**RE: Voss Property; NPDES Permit # 1GC04441\*AG; Compliance Inspection Findings and Notice of Violation**

Ohio EPA DSW Storm Water Section, Construction Site Visit Information Form

Site Name: Voss Property

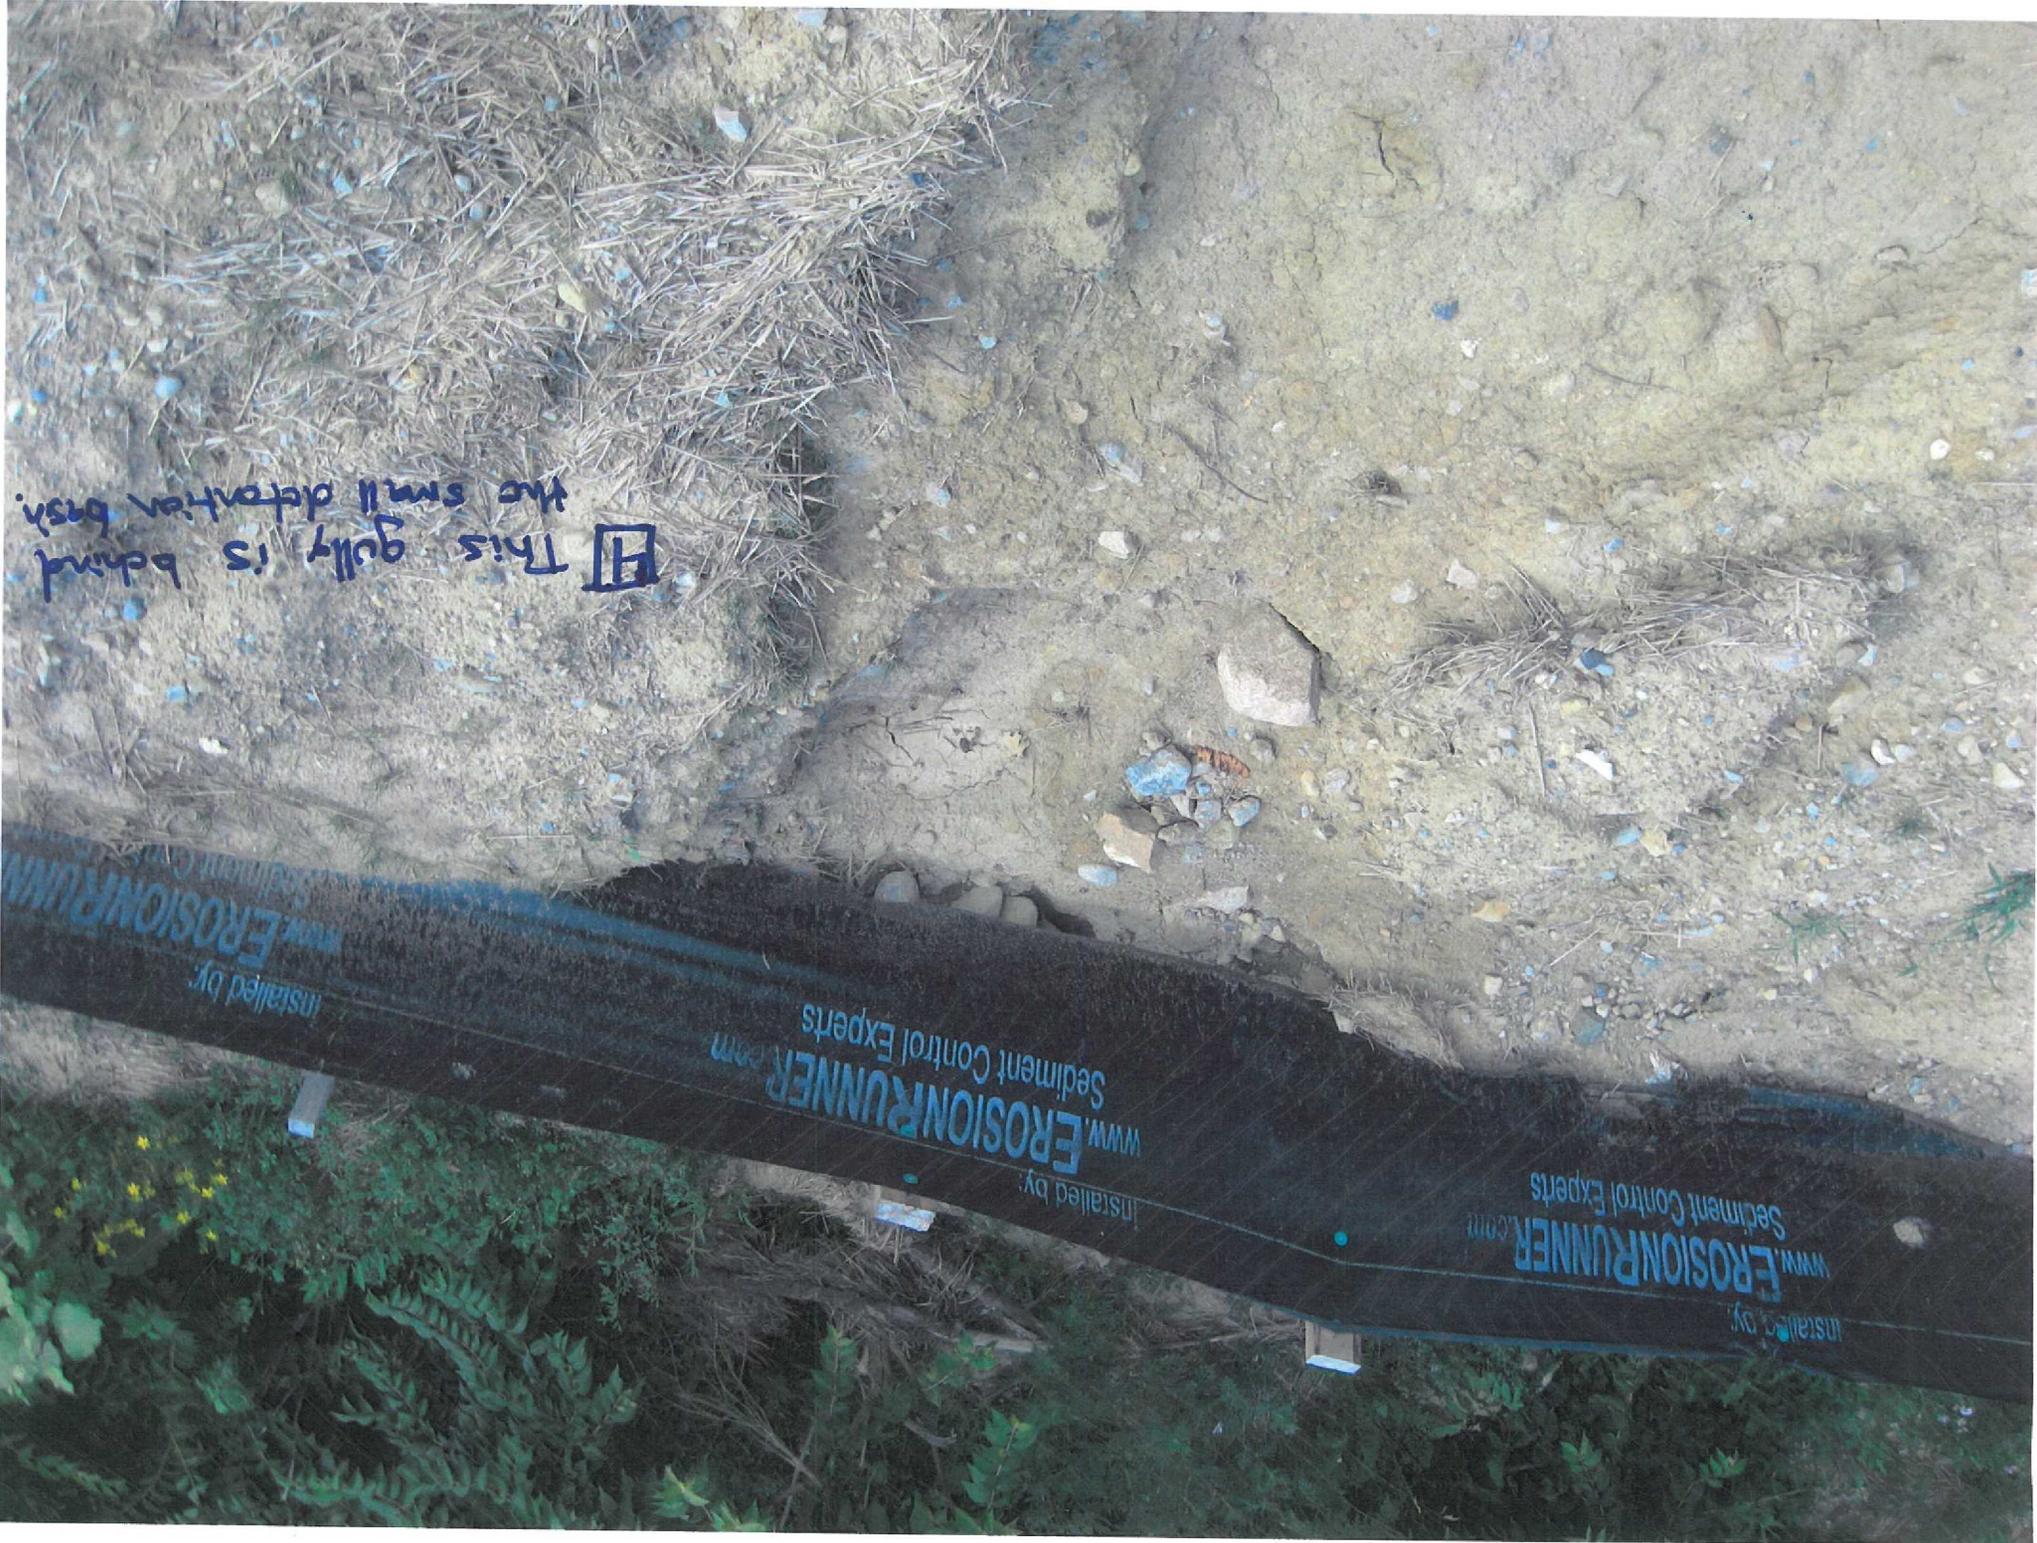
- Silt Fence needs to be maintained, Blow outs are allowing gullies to form, allowing sediment laden water to flow off site and down hill
- Permanently stabilize Hill sides (Attempt of stabilization is about 50%)  
 = re-seed and straw plus add straw mulch to reduce erosion
- Blow out on hill sides below dam structure needs to be fixed

Accumulated sediment  
needs to be removed at the  
base of the hill in order  
for the silt fence to be  
effective.

[Z] Blowouts have occurred underneath the small Detention Basin around the storm drain inlet.

☐ This gully is behind the small detention basin.

3 Maintenance required  
for the silt fence in  
several locations.

3 Example of gullies forming underneath the silt fence.
